Topic	GTC hood ram – cover deletion (SC14/13)
Market area	United Kingdom E01 Bentley UK (6E01),Germany E02 Bentley rest Europe (6E02),United States E05 Bentley USA and rest America (6E05)
Brand	Bentley
Transaction No.	2037493/4
Campaign number	EA13
Note	
Type	Service campaign
US code

New GTC

Figure 2

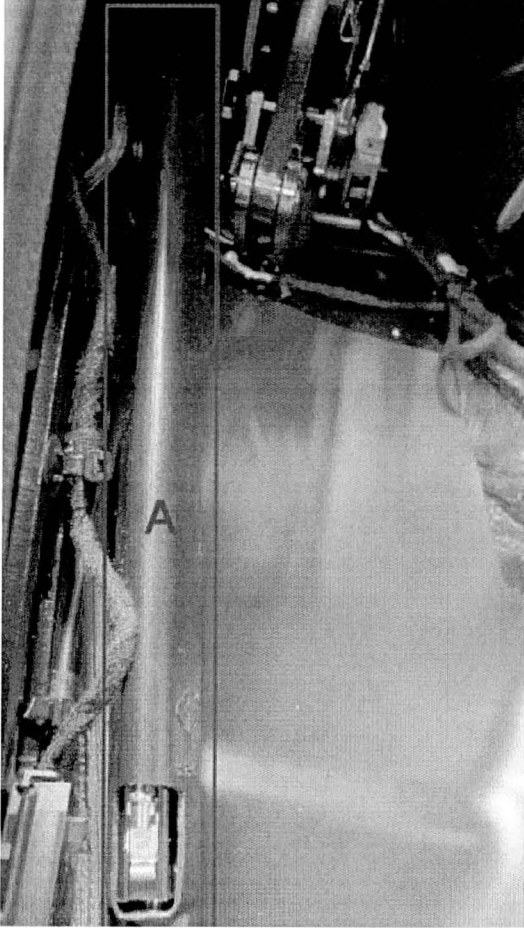
2. Identify the plastic cover 'A' fitted to the tonneau ram (see Figure 2)

Figure 3

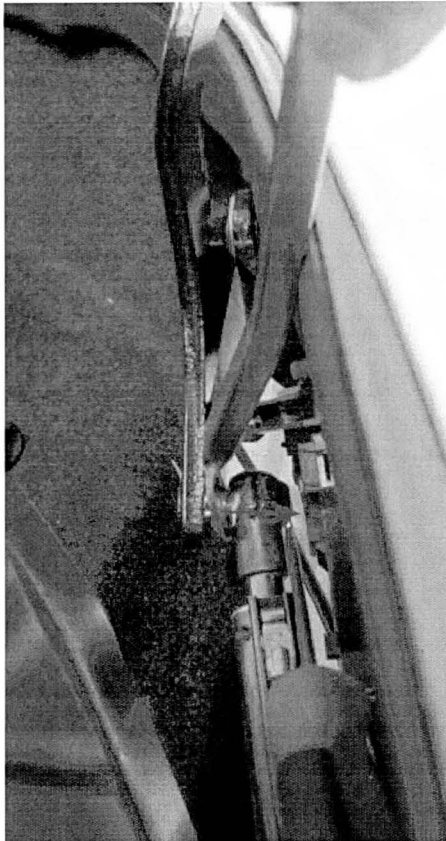
3. Partially release the ram ball end retaining clip before releasing the ram from the ball end pin (see Figure 2)

Figure 4

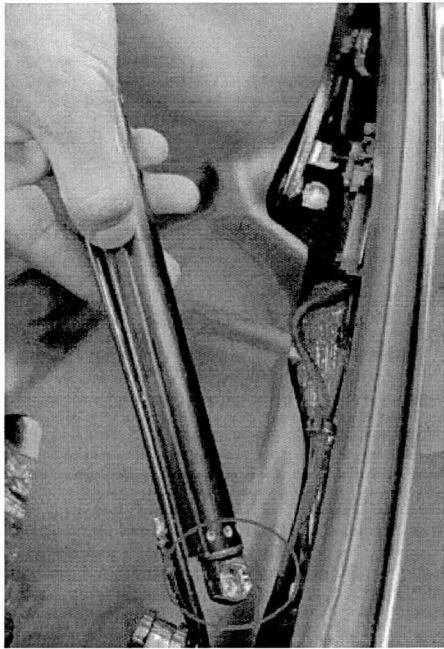
4. Lift the ram and slide off plastic cover 'A', discard cover. (see Figure 4)

Figure 6

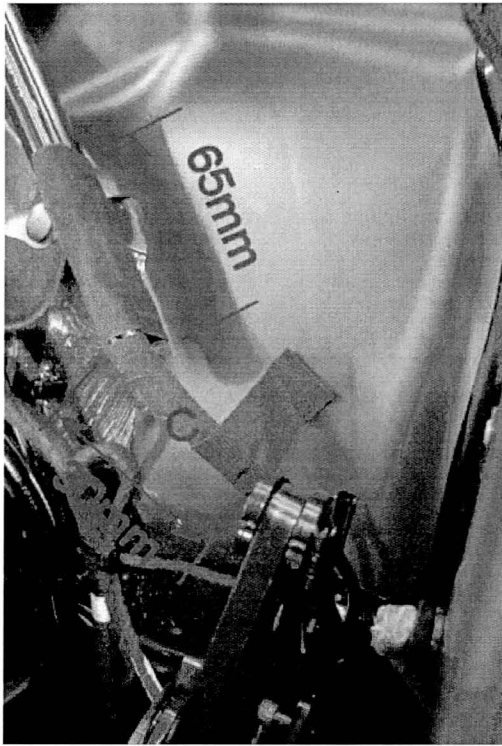
6. Apply anti-creak tape to the ram, enclosing the two hoses and tape up to but not over the ball pin receiver 'B', approximately 65mm of the ram (see Figure 6).

Figure 8 shows the completed taping exercise

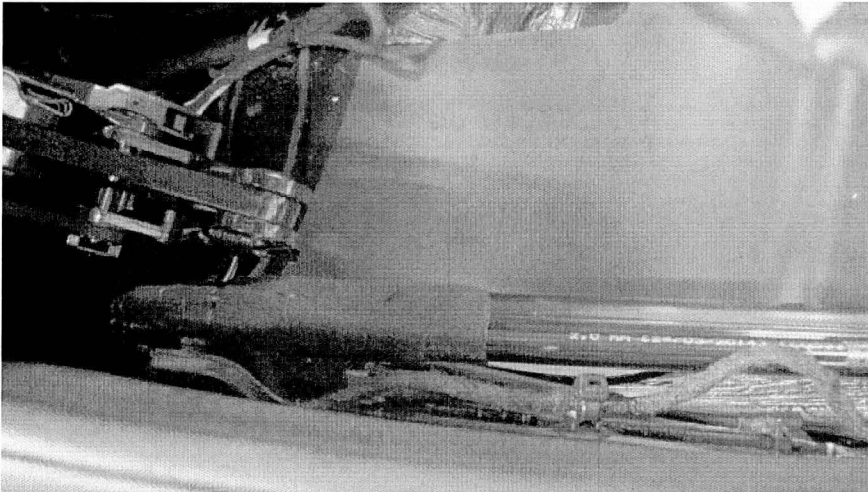
7. Apply a second layer of tape over the two hose as they exit the end of the ram approximately 30mm of hose should be covered (see Figure 7)
8. Refit the ram pushing each end onto its respective ball pin
